DEPARTMENT OF HAWAIIAN HOME LANDS
STATE OF HAWAII

ADDENDUM NO. 2

**PAPAKOLEA SUBDIVISION SEWER IMPROVEMENTS
SEWER LINES E, F, L, A, C, D AND K-3 IMPROVEMENTS**

IFB-17-HHL-010

TRAFFIC CONTROL PLAN - 7
SEWER LINE "D"
SMH. 318759 TO SMH. 318741
(24-HOUR)

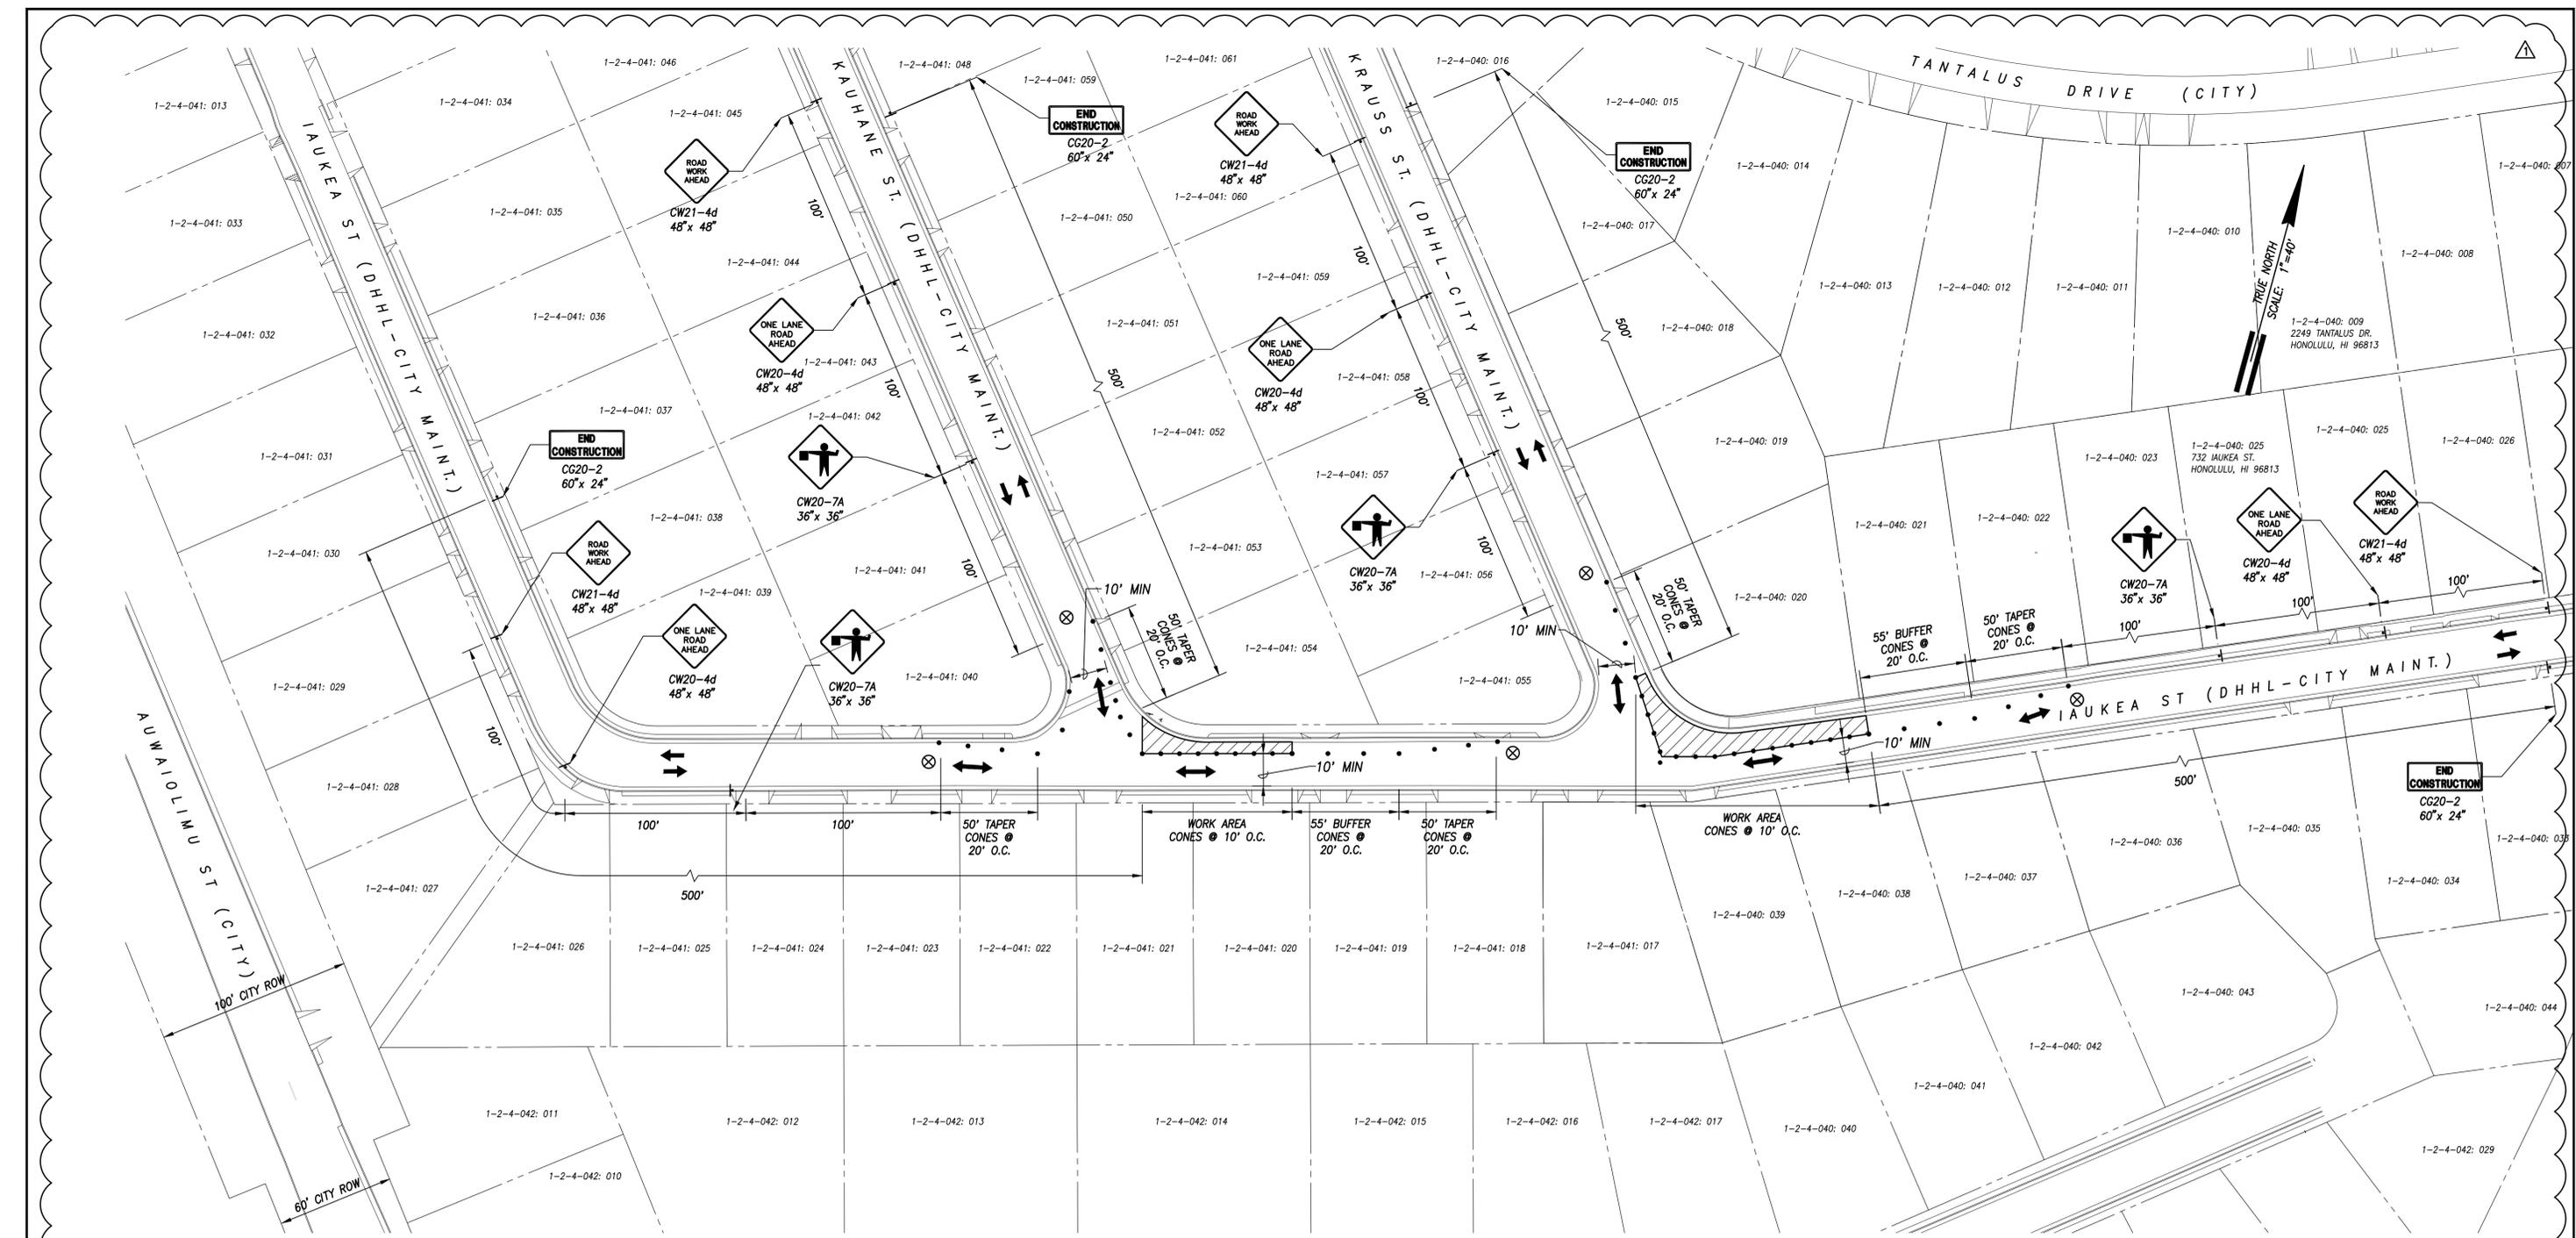
15. Sheet C-34 – “Traffic Control Plan - 6 Sewer Line D SMH 318812 to SMH 318759 - 24-Hour”
Revised traffic control plan.
16. Sheet C-35 – “Traffic Control Plan - 7 Sewer Line D SMH 318759 to SMH 318741 - 24-Hour”
Revised traffic control plan.

TRAFFIC CONTROL PLAN – 8
SEWER LINE "D"
SMH. 318741 TO SMH. 318713
(24-HOUR)

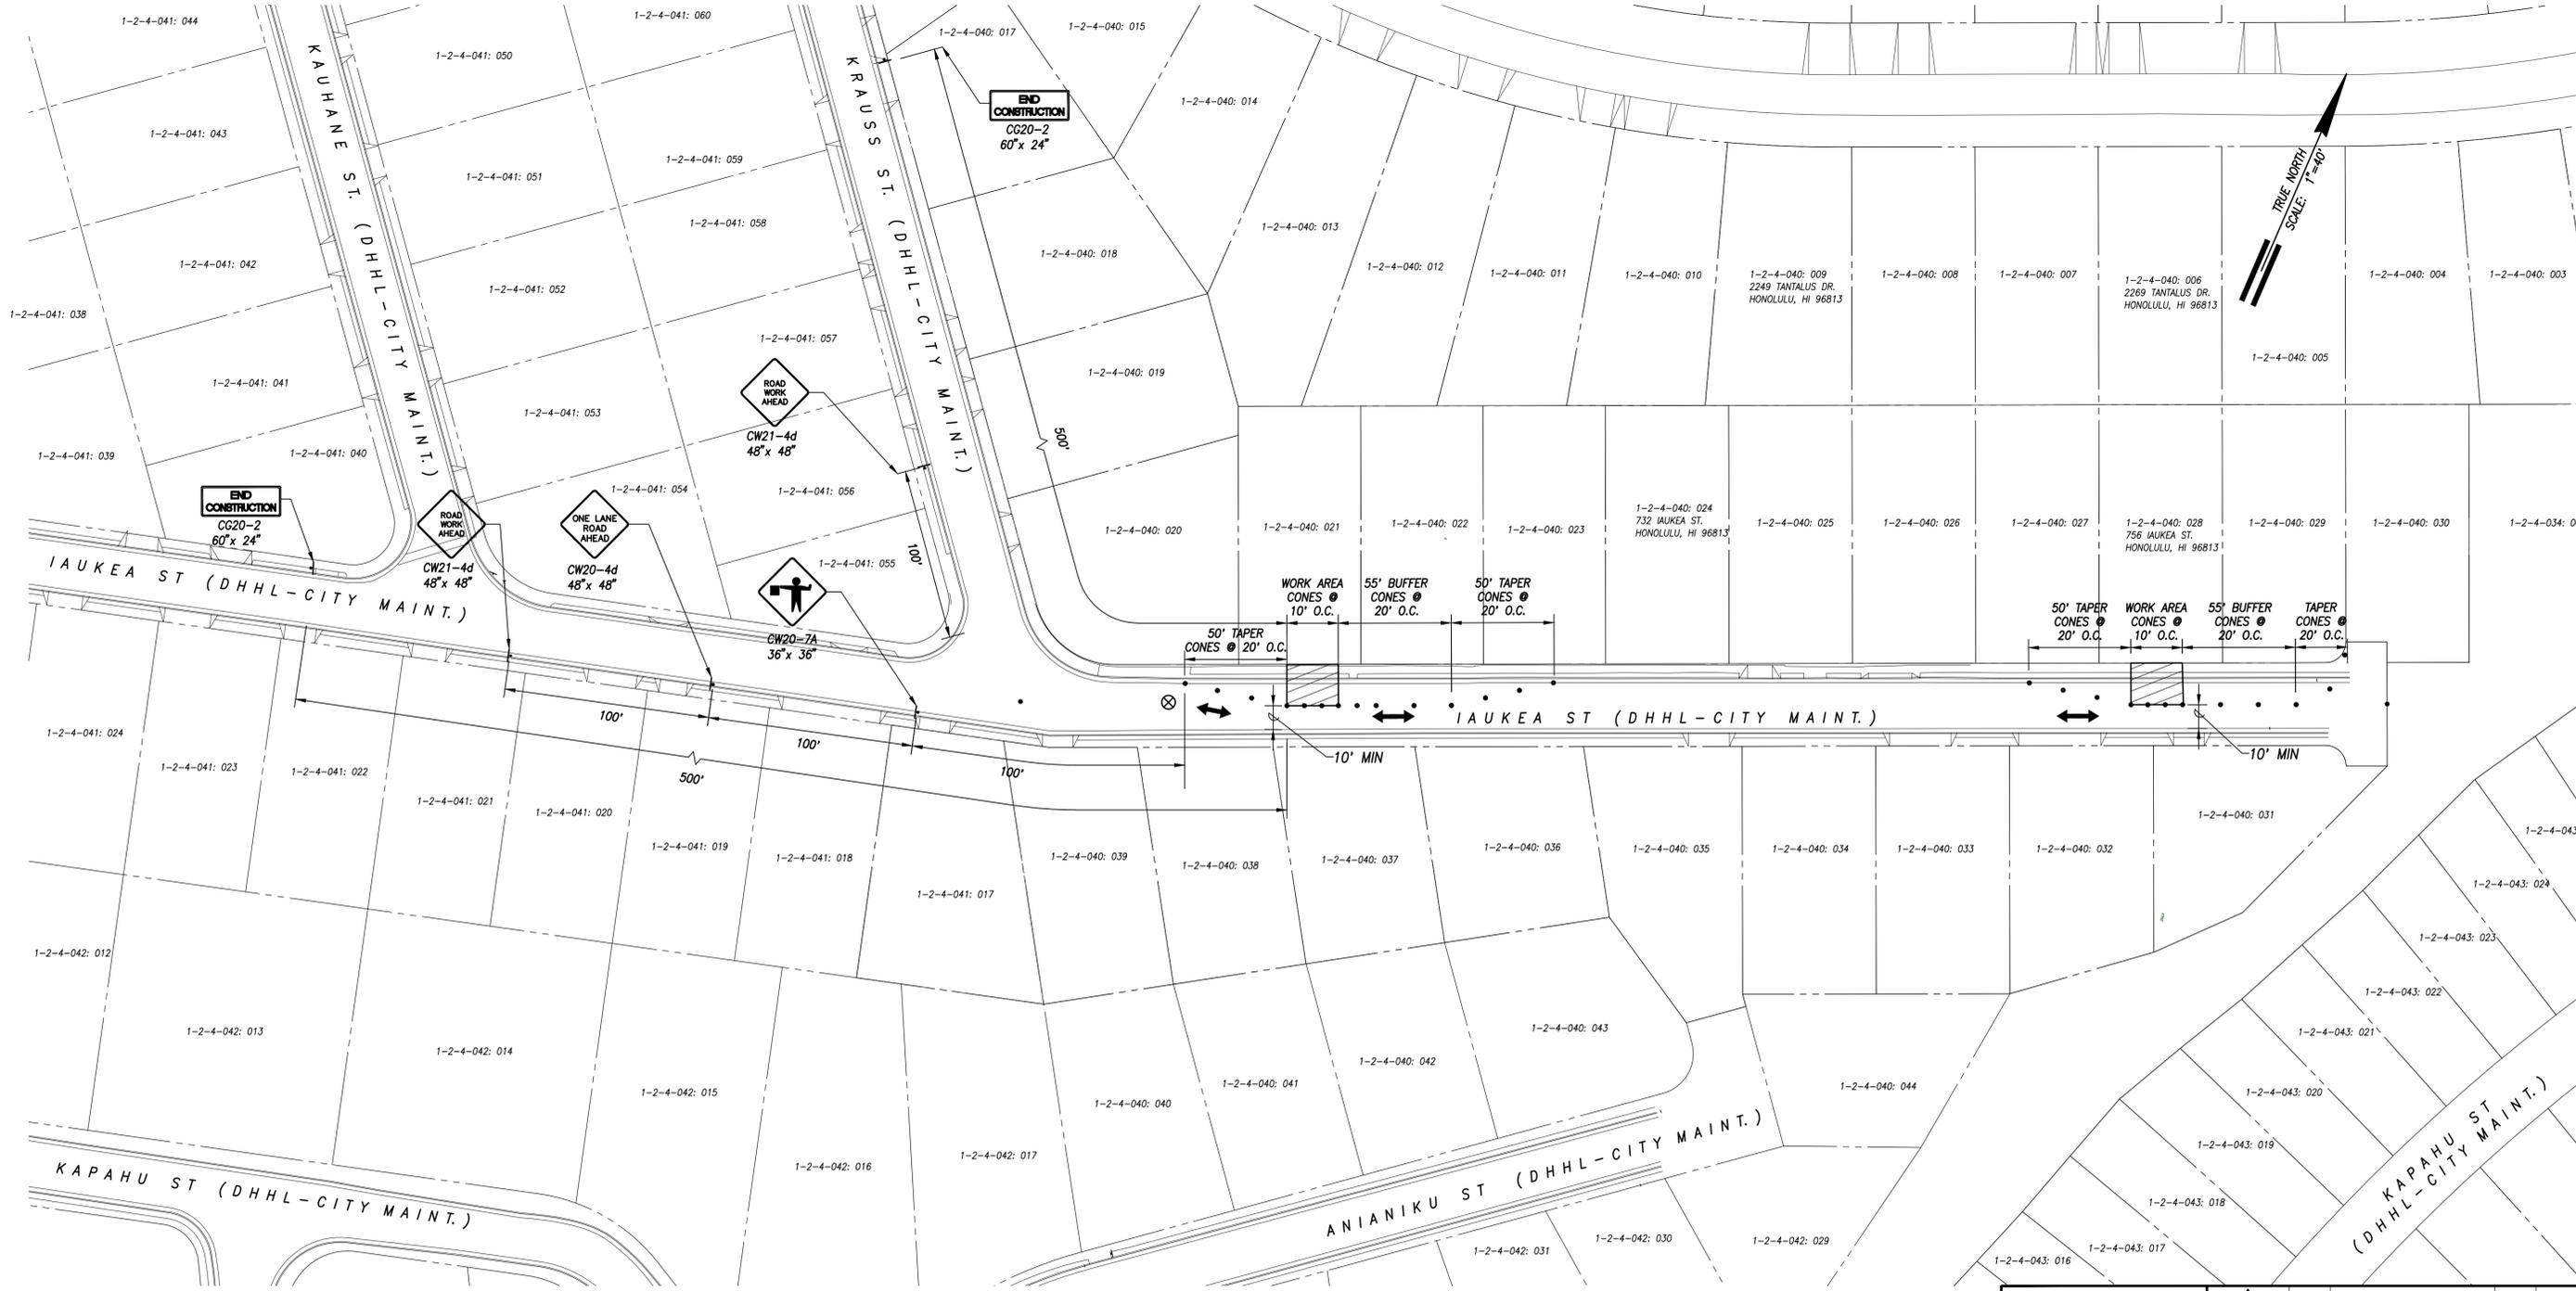
17. Sheet C-36 – “Traffic Control Plan - 8 Sewer Line D SMH 318741 to SMH 318713 - 24-Hour”
Revised traffic control plan.
18. Sheet C-37 – “Traffic Control Plan - 9 Sewer Line K-3 - 24-Hour”
Revised traffic control plan.

TRAFFIC CONTROL PLAN – SEWER LINE "L" (8:30AM–3:30PM)
 SCALE: 1" = 40'

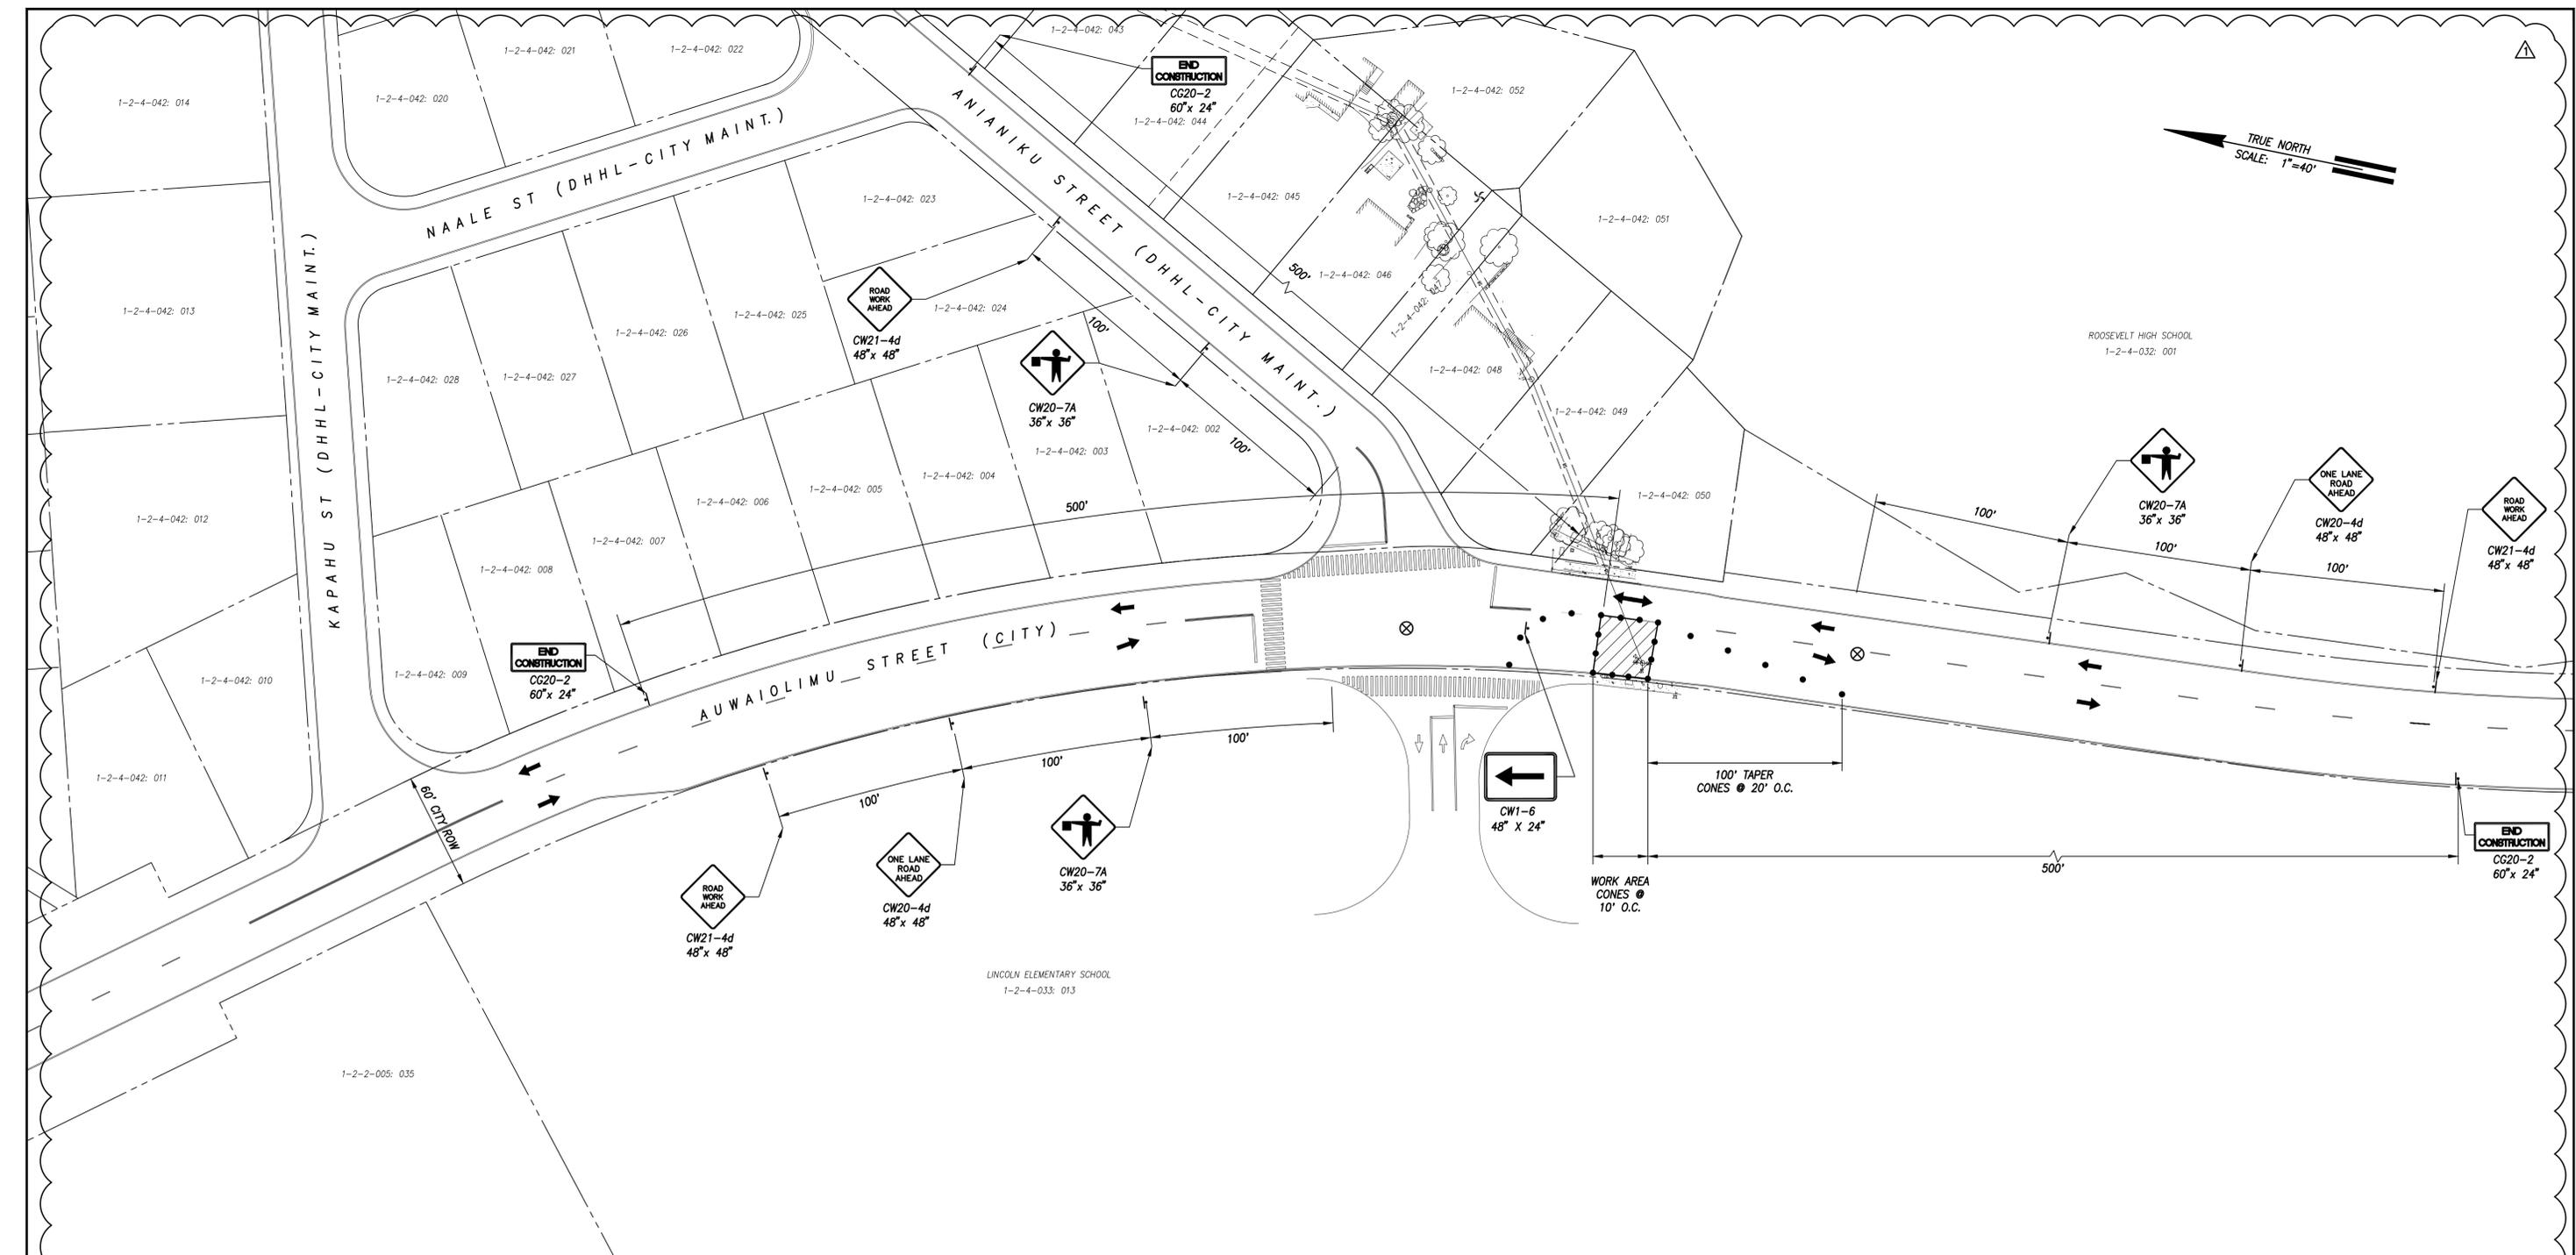
19. Sheet C-38 – “Traffic Control Plan - 10 Sewer Line L - 8:30am-3:30pm”
Revised traffic control plan.
